Amendment to 2016 Standard Specifications for Highways Construction

Section SS635 Electrical and Signing

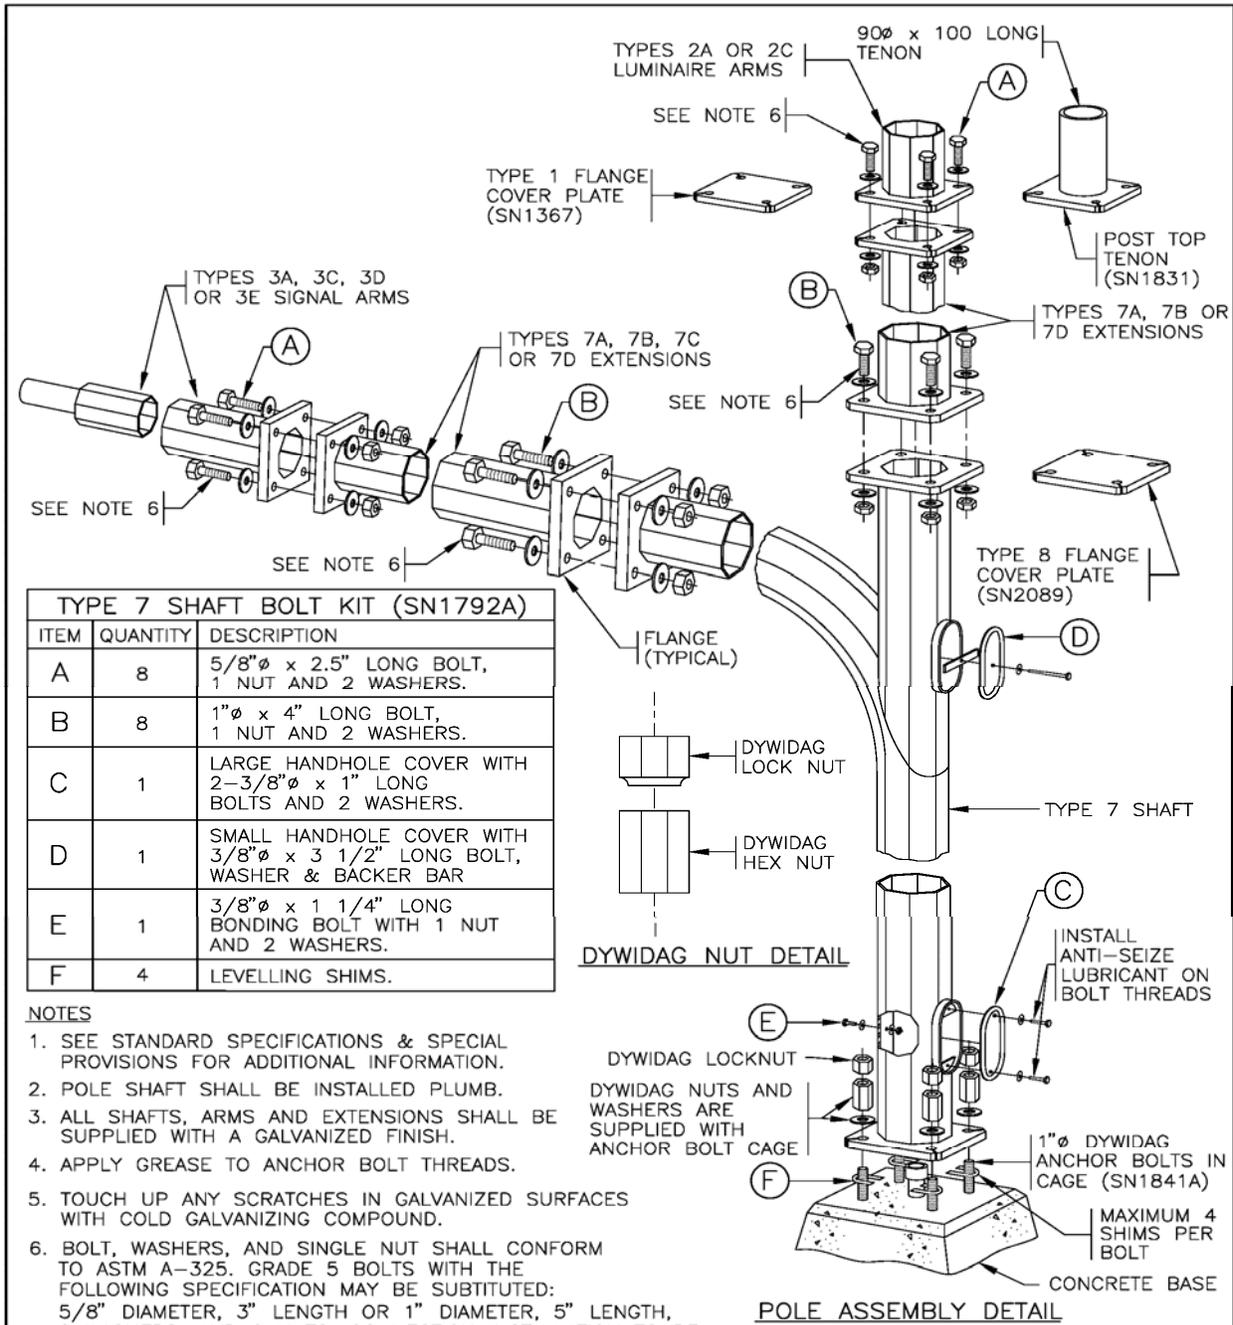
1. 2.1.14 and 2.1.15 are missing (should be reinstated on pages 107 & 108).
2. Drawing numbers 2.3.14 and 2.4.15 (page 107 & 108) appear in the 2.1xx series where 2.1.14 and 2.1.15 should be. 2.3.14 should follow 2.3.13, and 2.4.15 should follow 2.4.14
3. Drawing 2.4.8 is duplicated (page 140 & 141)
4. There is a drawing number 2.4.16 (page 154) after drawing number 2.4.20 (page 153). This drawing should be omitted. Just to be clear, there is already a drawing numbered 2.4.16 located between .15 and .17 in the 2.4.xx series; this drawing should remain where it is.
